**Environment Resources Authority (ERA)
Report on Environmental Planning Statement (EPS) – January 2018**

PA05477/16: PROPOSED FUEL SERVICE STATION, INCLUDING GROUND FLOOR CLASS 4B SHOP, TYRE SERVICE GARAGE, VRT GARAGE, ATM, CAR WASH FACILITIES, STORAGE AT FIRST FLOOR LEVEL AND INSTALLATION OF PV PANELS AT ROOF LEVEL

SITE AT, TRIQ HAL QORMI, LUQA, MALTA

Figure 1. Viewpoint 1 photomontage

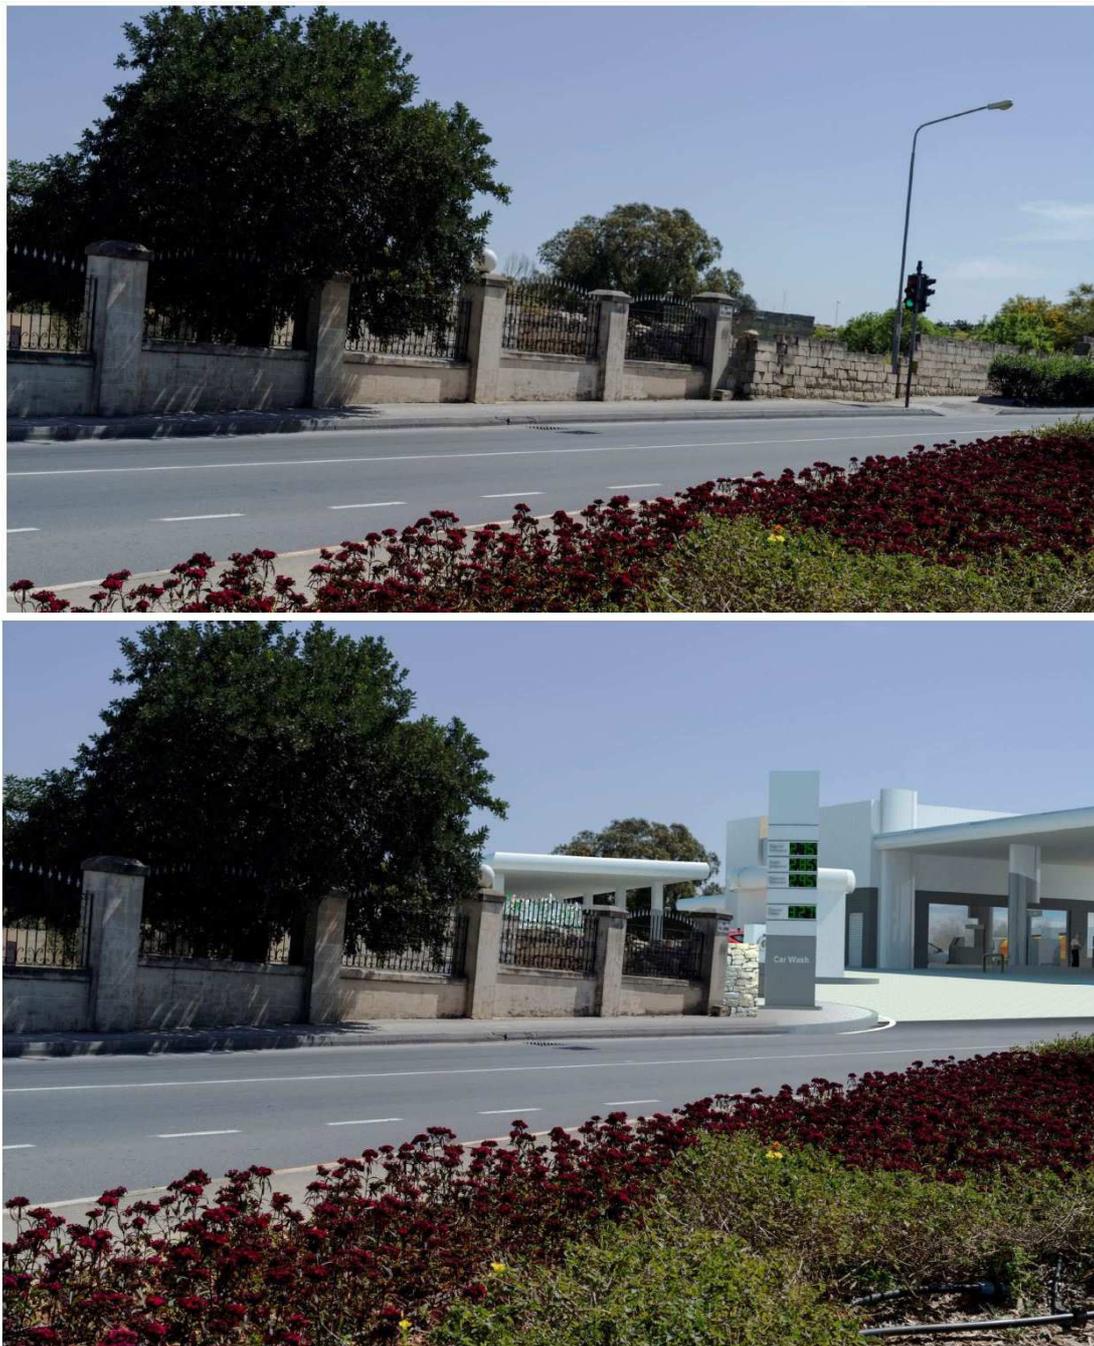
The only impacts on landscape and visual amenity are envisaged from Viewpoints 1, 2 and 5, where the project contrasts with the surroundings, with no impact being perceived at the rest of the viewpoints.
